## Memorandum

Winnetka Park District

Subject: Special Use Permit Review #1 – Centennial Park + Beach 255 Sheridan Road – (Case No. 24-08-SU) Review Responses (WPD)

Tree Preservation  
and Removals Plan

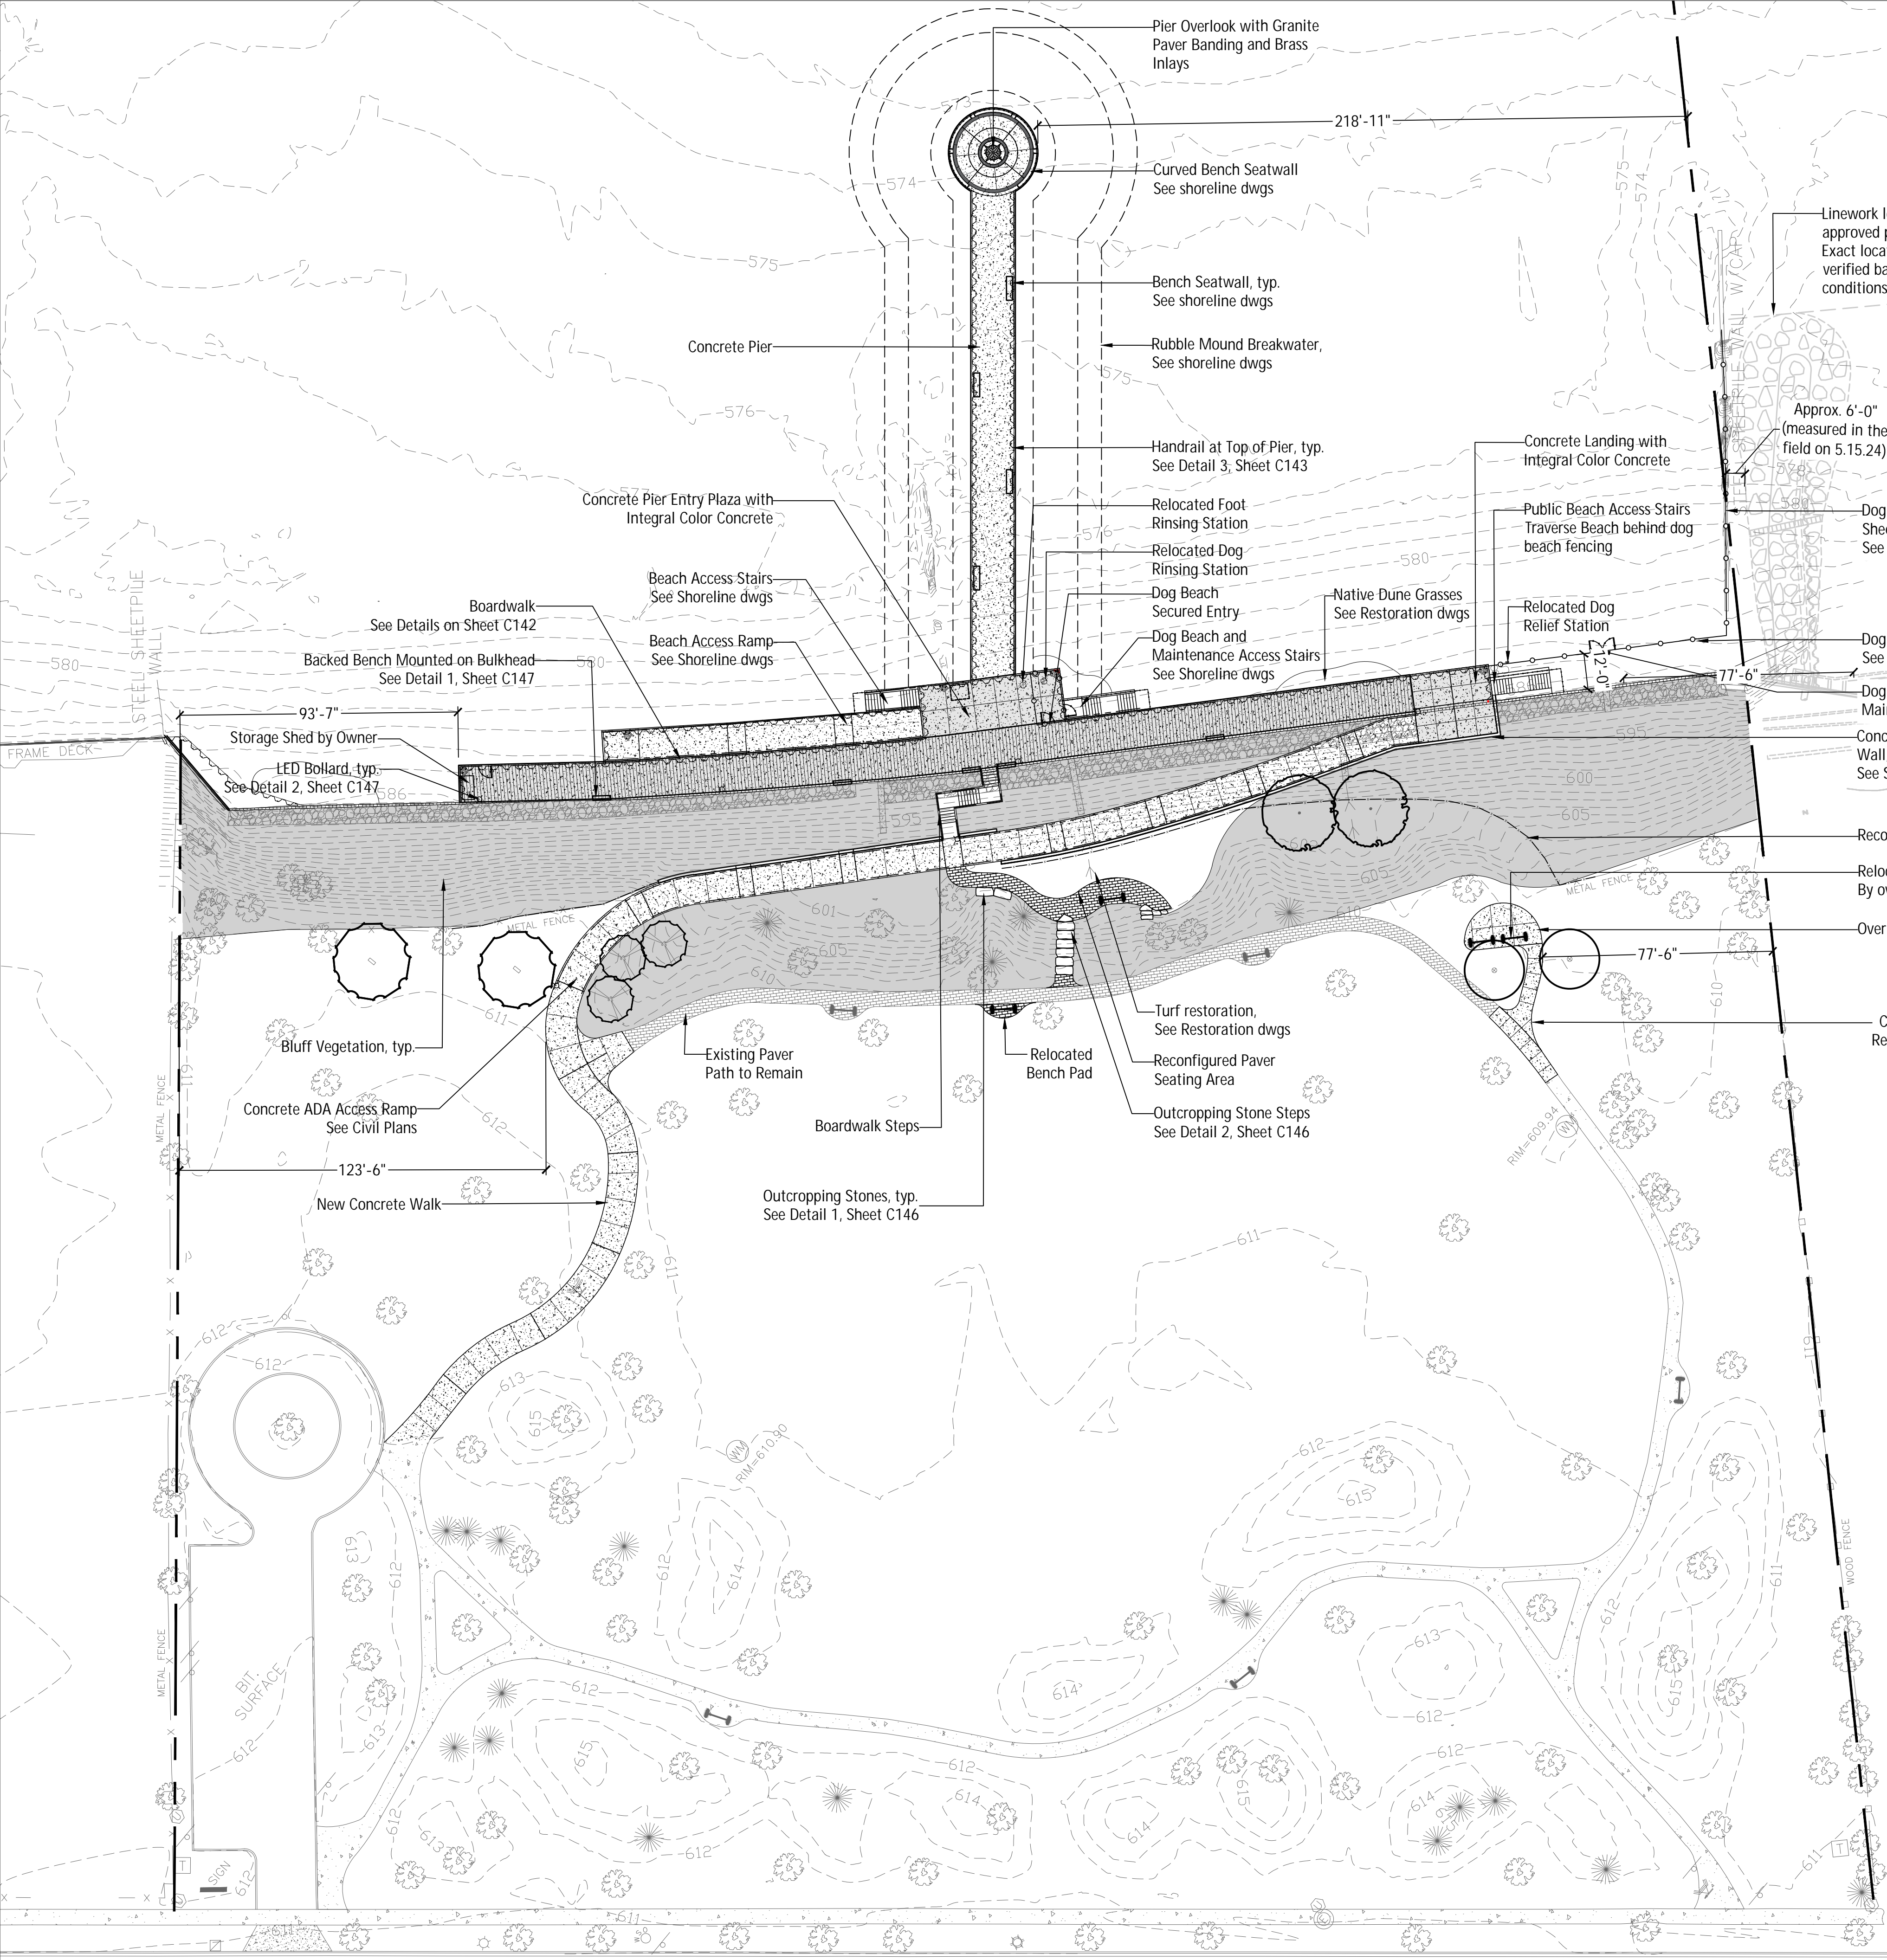
11. Provide a tree preservation plan and a landscape plan, including a list of proposed plant materials.

10. If any trees are proposed to be removed as part of the proposed improvements coordination with the Village Forester is required at this time. Tree mitigation will be considered as part of final approval.

**Response: Tree preservation plan is provided, see sheet C136. Landscape plan and Restoration Notes are provided, see sheets C139 and C149.**

**Response: Tree removals and preservation plan is provided with tree mitigation chart located on sheet C136. A portion of required replacements are shown on the Landscape Plan for restoration objectives, see sheet C139. It is the park district's intention to balance restoration objectives with the community's interest to preserve views to the lake.**

C137

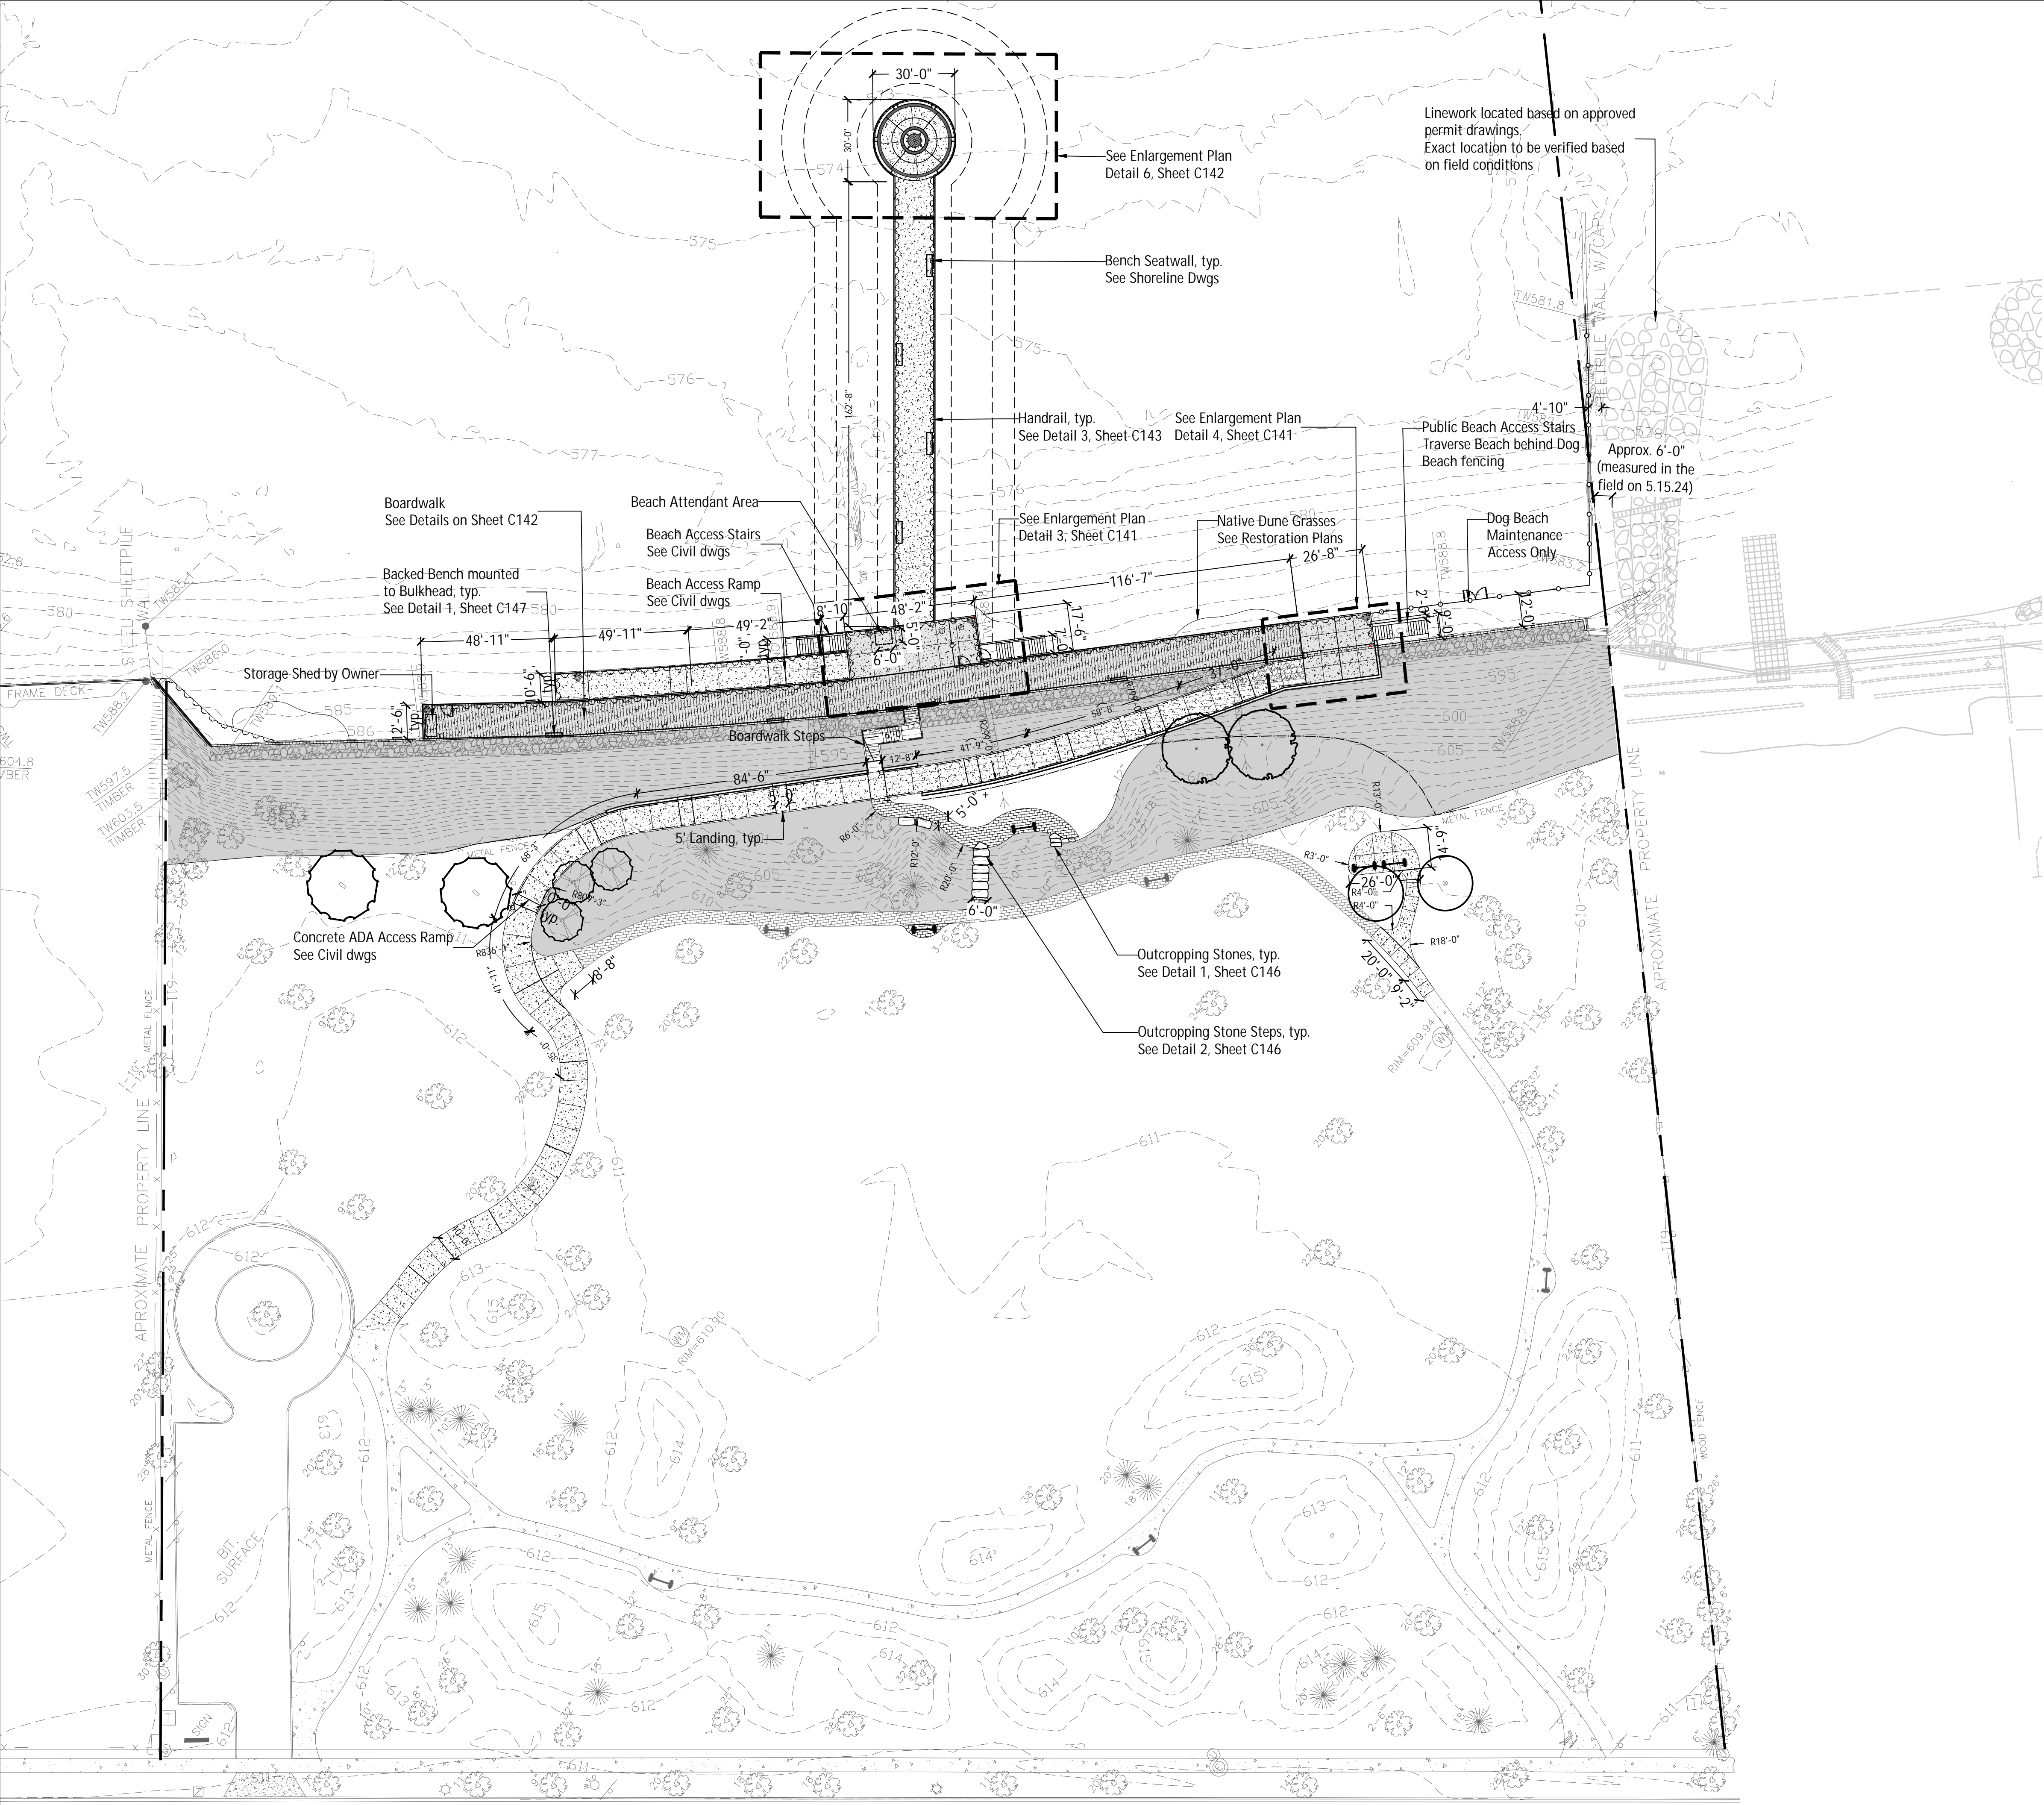
6. Clarify access through the dog beach for the public traversing the beach.

8. Once you define the steep slope zone, please describe as specifically as possible the requested exceptions (e.g., stairs (walkway) greater than five feet in width and landings greater than 50 square feet; any retaining walls being installed that are not for slope stabilization, such as for any new seating area within the steep slope zone, etc.)

19. Clearly label all elements of the plan on all plan sheets (e.g. the landing between the walkway and the boardwalk, the structure immediately to the south of this landing, the purpose of gate to the south of “Relocated Dog Relief Station”, etc.).

23. Provide details of proposed lights and identify all the proposed light fixtures on the plans.

**Response: Public access is not provided through the dog beach area but it is provided behind the dog beach area along the west and south shorelines. Notations have been added to the plan sheet C137 to indicate public access across the beach.**

**Response: The steep slope zone is identified on the plan sheet CS-6 and a chart of non-conforming elements is provided on the Overall Plan Sheet C137 to clarify elements requiring exceptions to build in the steep slope zone and within the 50' set back from the front yard ordinary high water mark.**

**Response: Labels are provided on updated plans, see sheets C137.**

**Response: Low-level bollard light locations are provided on the plans, see sheet C137. Light fixture cut sheets are provided on sheet C147.**
